MCGOWIN BUSINESS PARK SUBDIVISION,

PHASE FIVE

APPLICATION NUMBER 5 DATE November 3, 2016

REQUEST Subdivision

DETAIL SITE PLAN

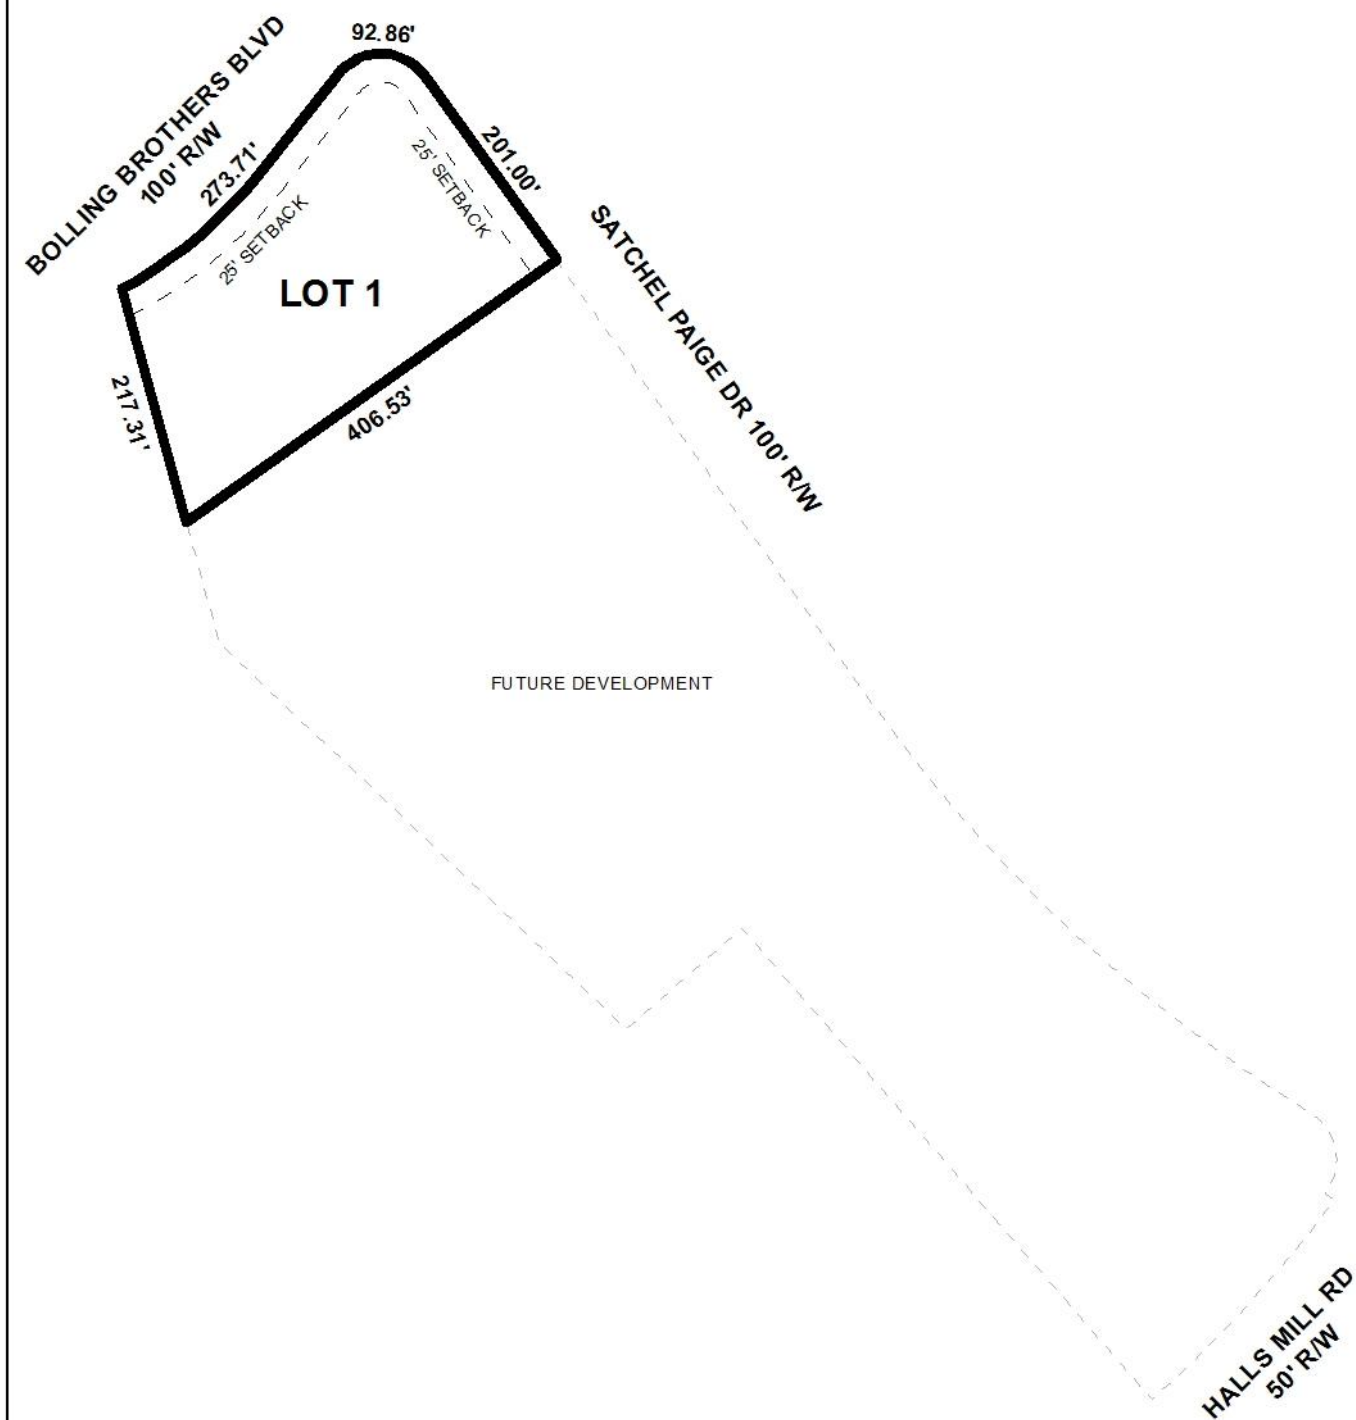
- G. The existing drainage ditch that runs through the "FUTURE DEVELOPMENT" needs to be contained in a PUBLIC DRAINAGE EASEMENT (Dedicated to the City of Mobile). The width and alignment of the easement will need to allow vehicular and equipment access, and shall be coordinated with, and approved by, the City Engineer.

Traffic Engineering Comments: Lot 1 is limited to one curb cut per street frontage, with size, location and design to be approved by Traffic Engineering and conform to AASHTO standards. Additional driveway restrictions for the "Future Development" parcel to be determined upon future subdivision, which will include the denial of access to Halls Mill Road. Required on-site parking, including ADA handicap spaces, shall meet the minimum standards as defined in Section 64-6 of the City's Zoning Ordinance.

The lot will have approximately 245 feet of frontage on Satchel Paige Drive and approximately 319 feet on Bolling Brothers Boulevard. Access management is a concern, however, due to the site's proximity to Bay Bears Stadium and the McGowin Park retail complex. The proposed lot should be limited to one (1) curb-cut to each street, with the size, design and location of all curb-cuts to be approved by Traffic Engineering and conform with AASHTO standards.

The 25-foot minimum building setback line, required in Section V.D.9., is shown for the subdivision and should be retained on the final plat, if approved.

- 1) depiction and labeling of the 25-foot minimum building setback line, required by Section V.D.9. of the Subdivision Regulations, on the final plat;

- 2) placement of a note on the final plat stating that the lot is limited to one (1) curb-cut to each street, with the size, design and location of all curb-cuts to be approved by Traffic Engineering and conform to AASHTO standards;

- 3) the entirety of the "future development" area to be submitted for the creation of one or more lots, if any portion of this area is proposed for subdivision in the future;
